### **Turkey Point Units 6 and 7 COL Application**

### **SSHAC Caribbean GMPE Questionnaire**

## **Review of Bechtel Caribbean GMPE Report**

# Response to SSHAC Caribbean GMPE Questionnaire

Figure 8. Magnitude and Distance Deaggregation for 1 and 2.5 Hz at  $10^{-4}$  and  $10^{-5}$  Annual Frequencies of Exceedance.

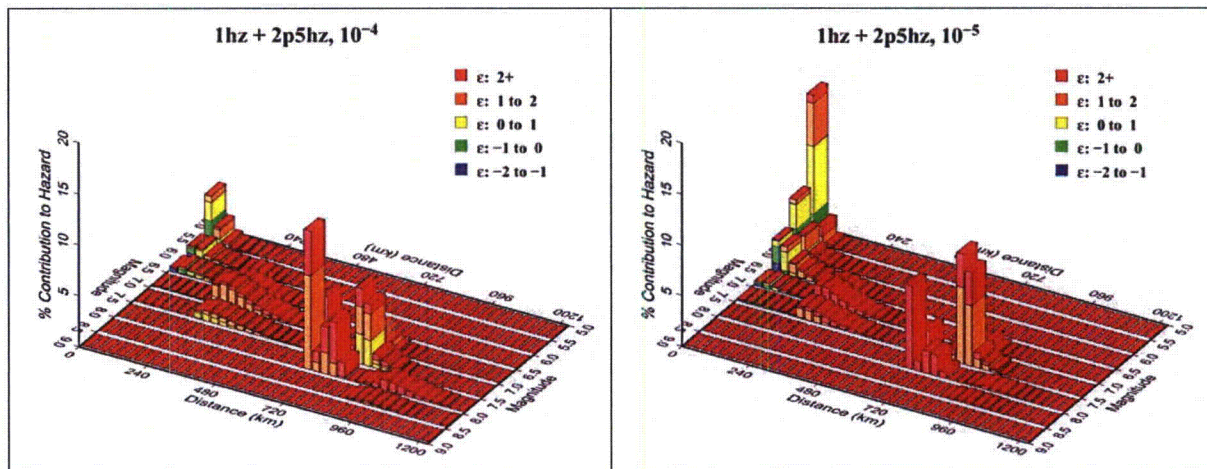
A7d. The deaggregation histograms show that the Caribbean sources are important to (and possibly even dominating) the seismic hazard at relatively low structural and exceedance frequencies. How about at higher structural frequencies? For completeness, I would like to see deaggregation plots at the higher structural frequencies.

Figure 10b. Comparison of Caribbean GMPE (red lines), EPRI Mid-Continent (blue lines) and Gulf Coast region (green lines) GMPE and empirical IRIS processed data for a spectral frequency of 1 Hz. The DWPF data point is shown as a blue-filled circle.

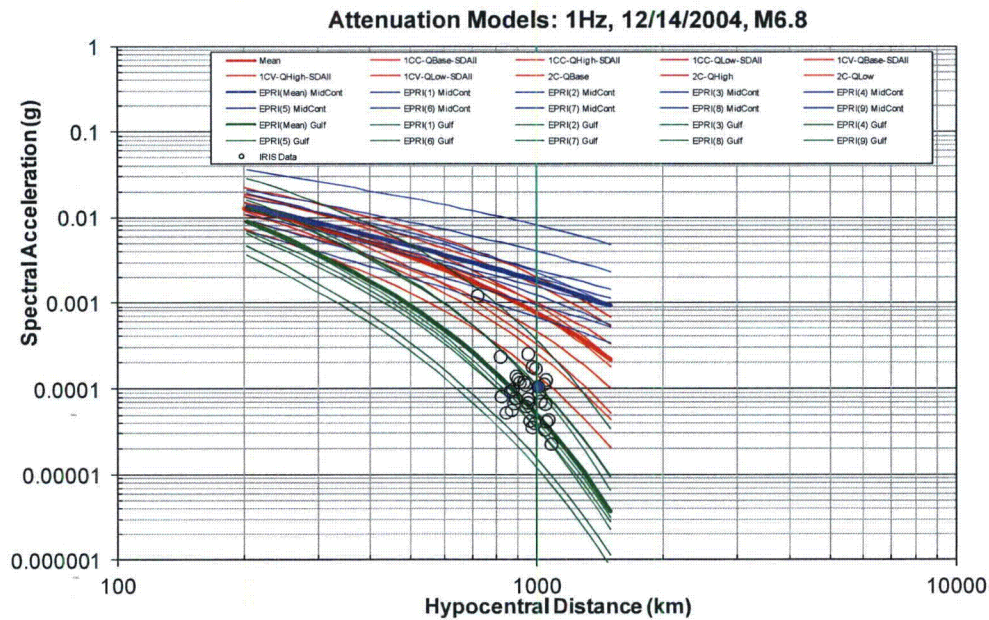
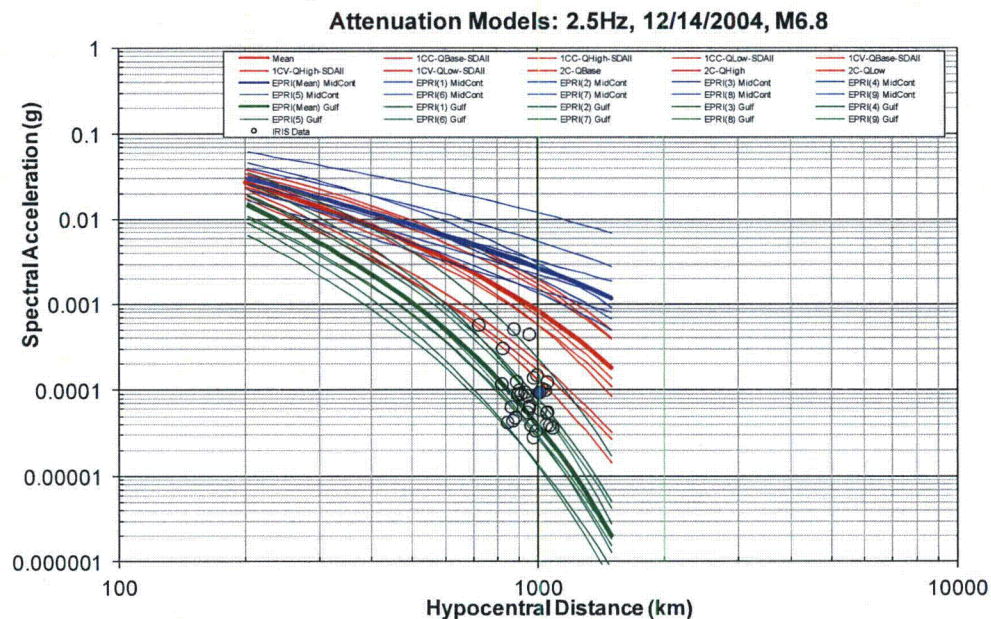
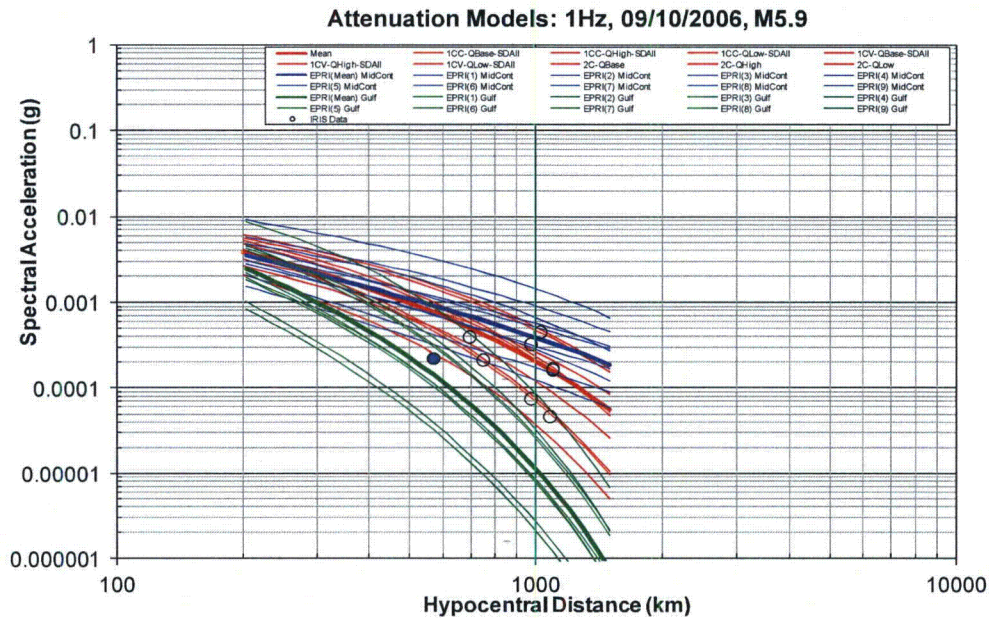
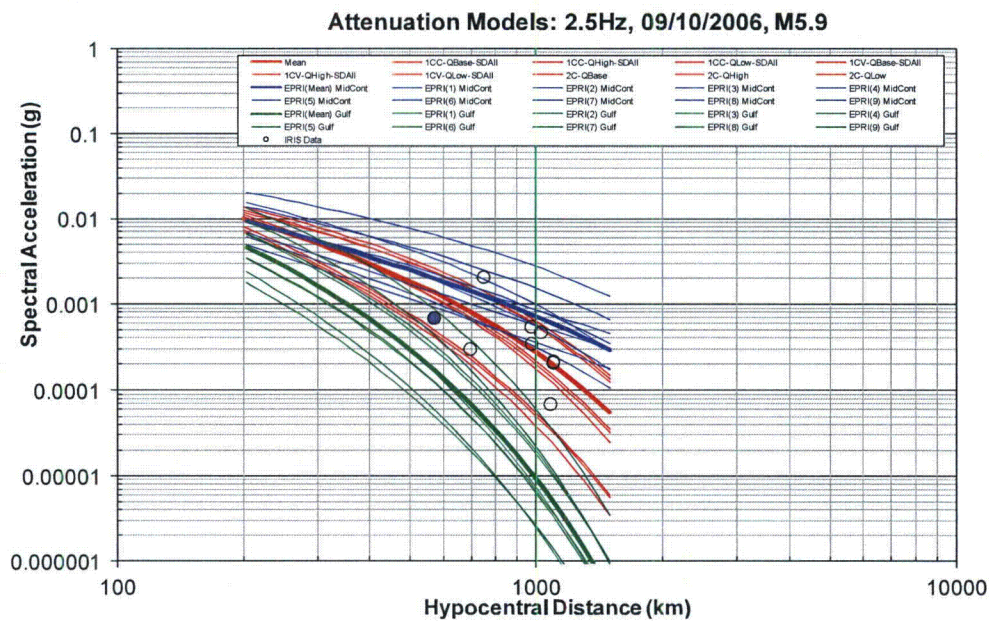
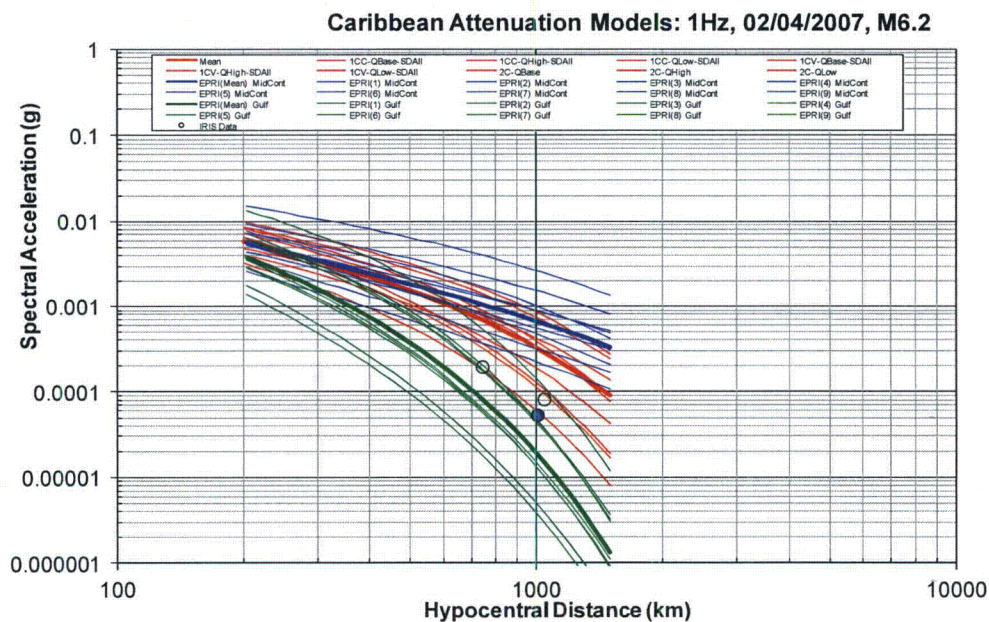
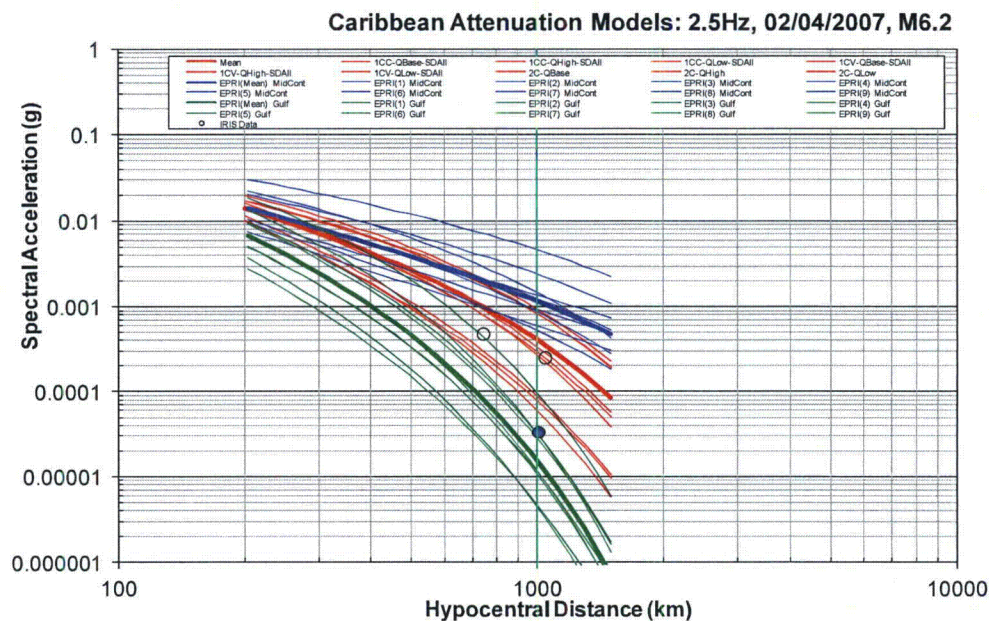
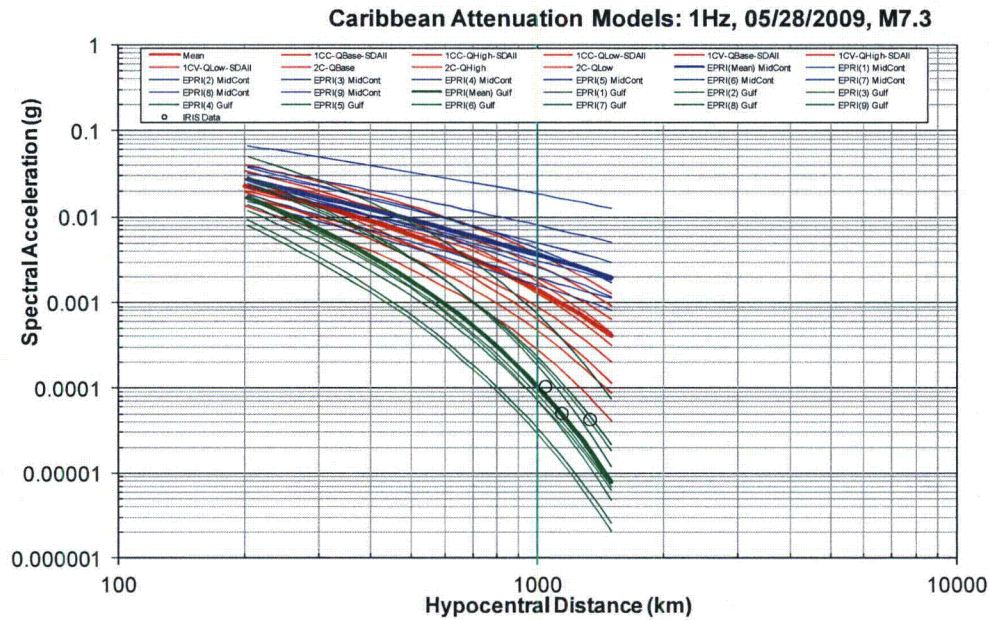
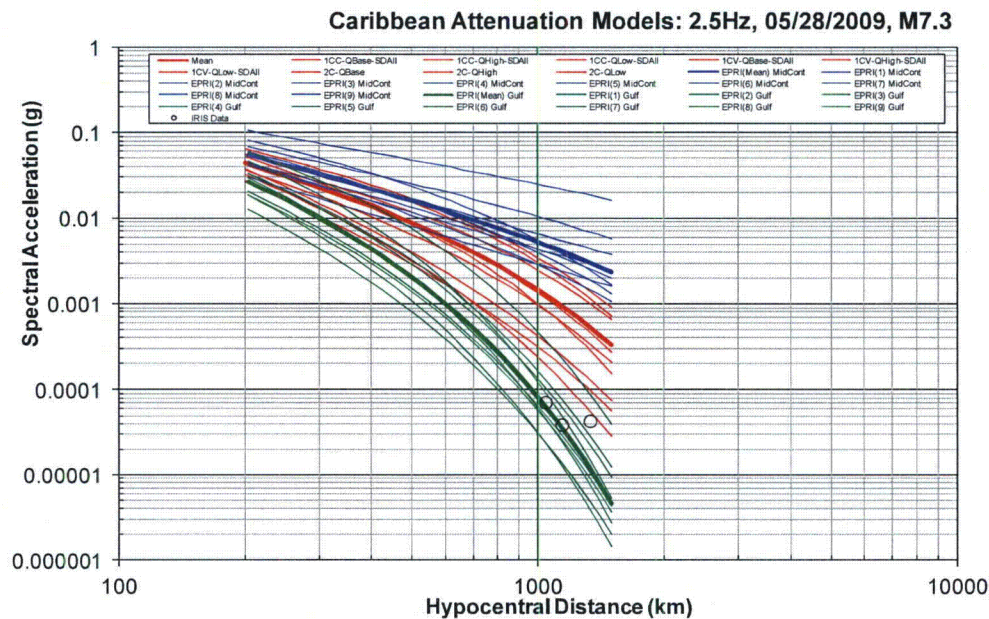
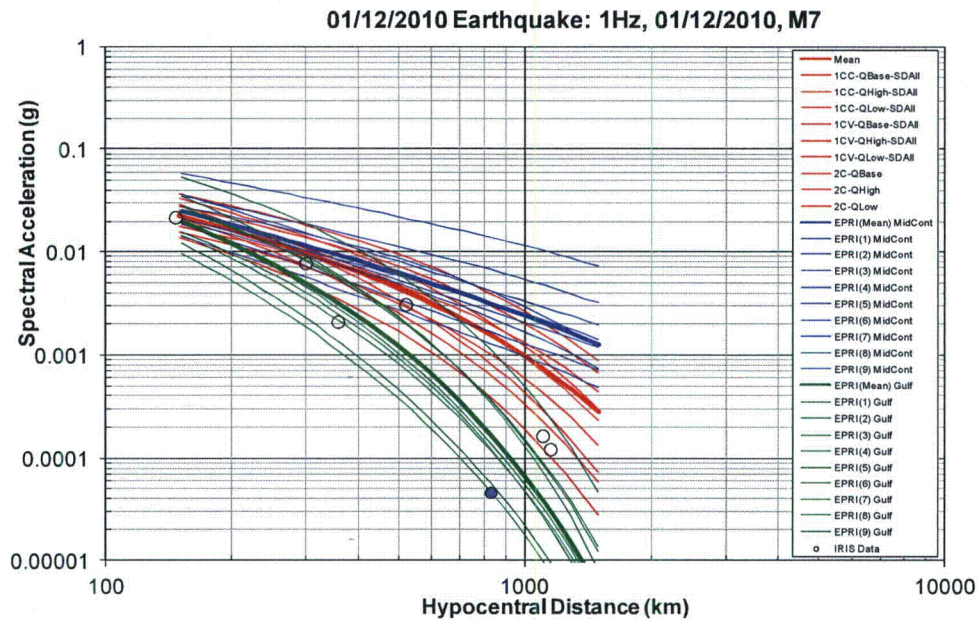
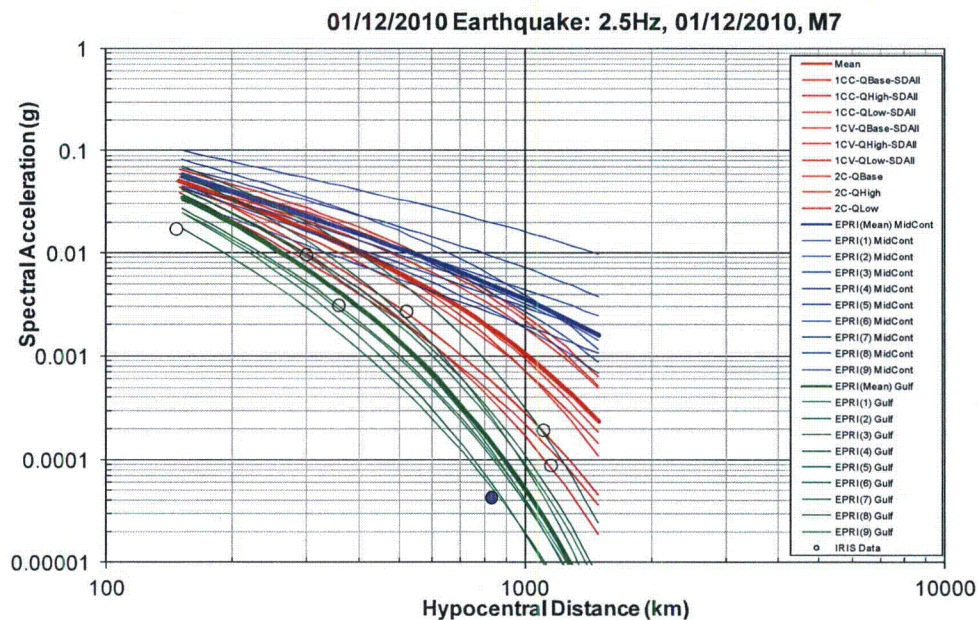
Based on the sensitivity analysis of five regional events reported in the Bechtel report, it seems that EPRI Gulf Coast GMPEs are more appropriate. However, it should be noted that the recorded empirical data were not corrected for local site effects to correspond the spectral ordinates of the recorded motions to  $V_s=2.83$  km/sec.

**(a)** In the sensitivity analysis, the site corrections at the recording sites to correspond the spectral ordinates to  $V_s=2.83$  km/sec should be carried out. Due to lack of specific soil data at the recording site, the site correction needs to be done in an approximation manner. There are different methods of approximating site correction that may be employed.

**(b)** In the sensitivity analysis, it would be useful to show the residual plots rather than the predicted curves superimposed over the recorded data. In this process, it would be also useful to estimate the "event terms" (and their uncertainties) for the earthquakes examined in the report.

region (see McNamara *et al.*, 2012). Now, I am glad that this has been done in the most recent report that has been provided to me (the SSHAC Caribbean GMPE Questionnaire). Therefore, the comparison of the developed Caribbean GMPEs with the EPRI (2004) Mid-Continent and Gulf Coast GMPEs has provided a good way to show the appropriate ranges of input parameters such as stress parameter that scales high frequency of ground motions have been selected. The Gulf of Mexico ( $M_w$  5.9) event is possibly a good representative of ground motions between the Cuba area and the FPL project site location that could be used to validate the selected parameters. This event shows that the selected seismological parameters are acceptable to capture the recording ground motion data (see Figures 10a and 10b).
